# Request for Quotation

RFQ NUMBER  
**7011EC14**

OPEN END CONTRACT  
FIVE CUBIC YARD STAINLESS STEEL DEMOUNTABLE ABRASIVE  
AND CHEMICAL SPREADER (HYDRAULIC)

RESPONSE TO QUESTIONS

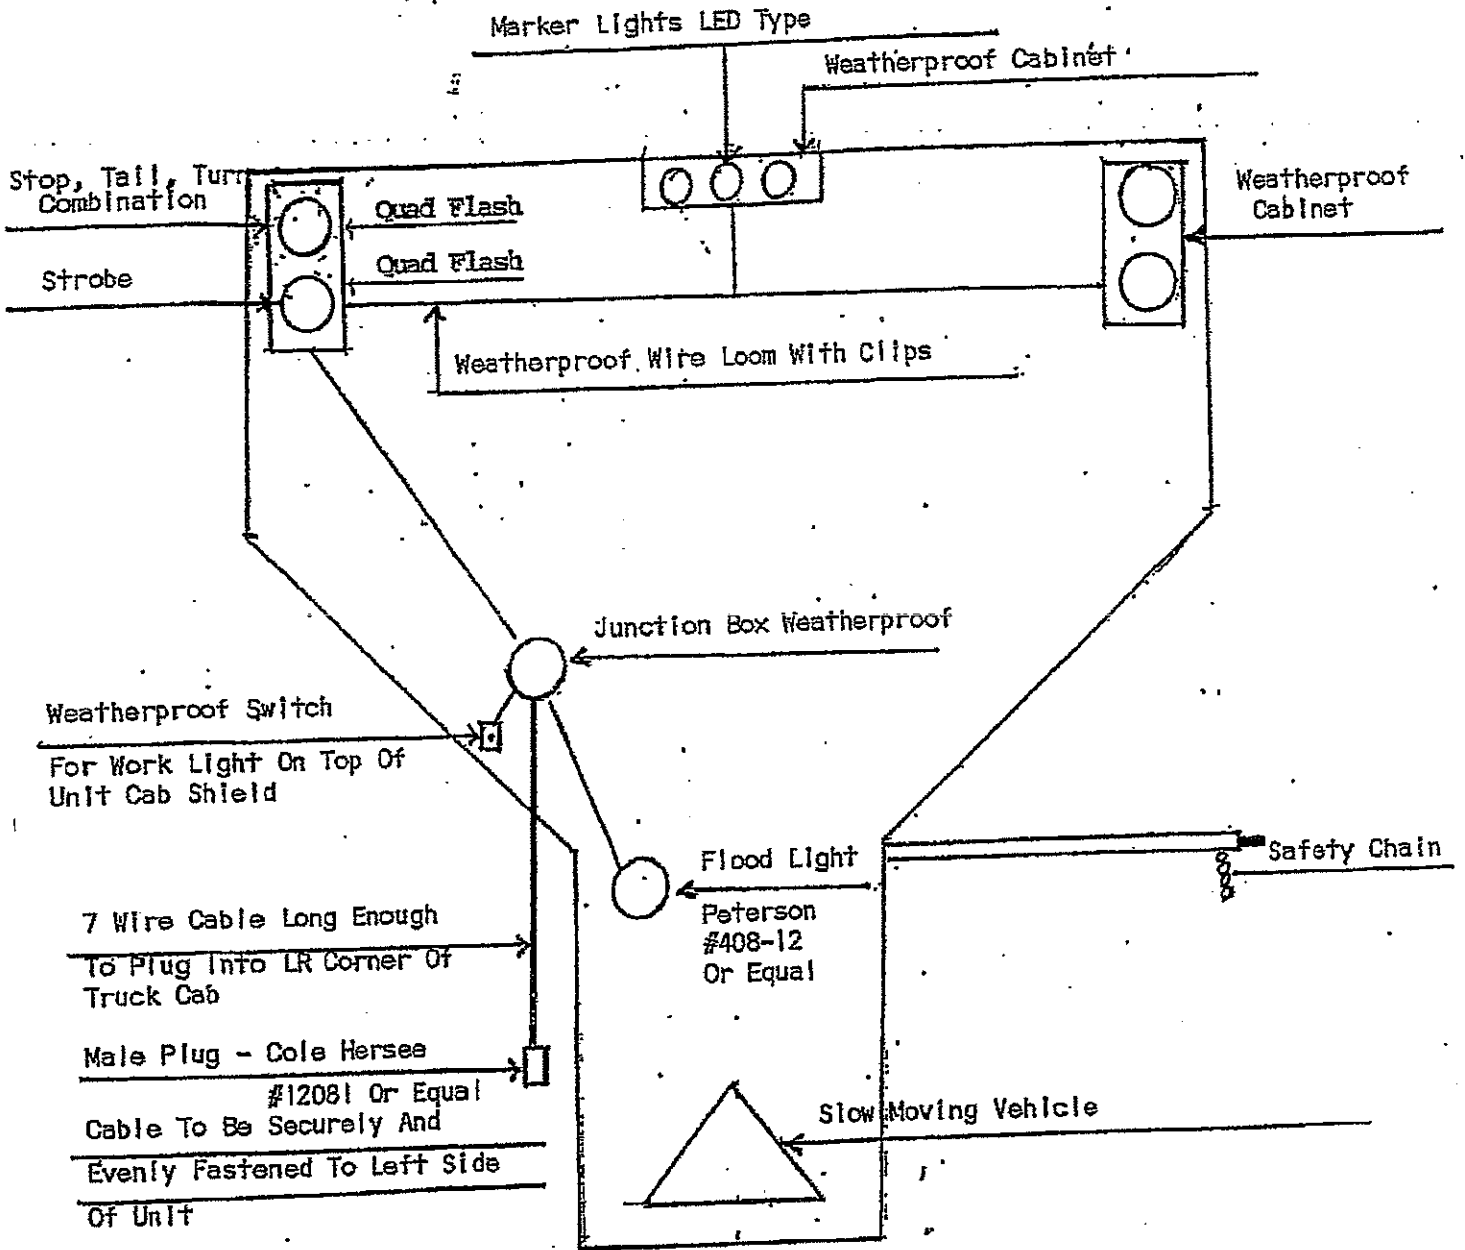
9. Is a 6.3 cubic yard capacity acceptable for RFQ14?  
**RESPONSE: No**
11. The lighting drawing shows lights combined in housings but previous spreaders have been supplied with individual weatherproof housing as per the picture below. Are the individual weatherproof housings still allowed?

**RESPONSE: As long as you still are in compliance with the spec.**
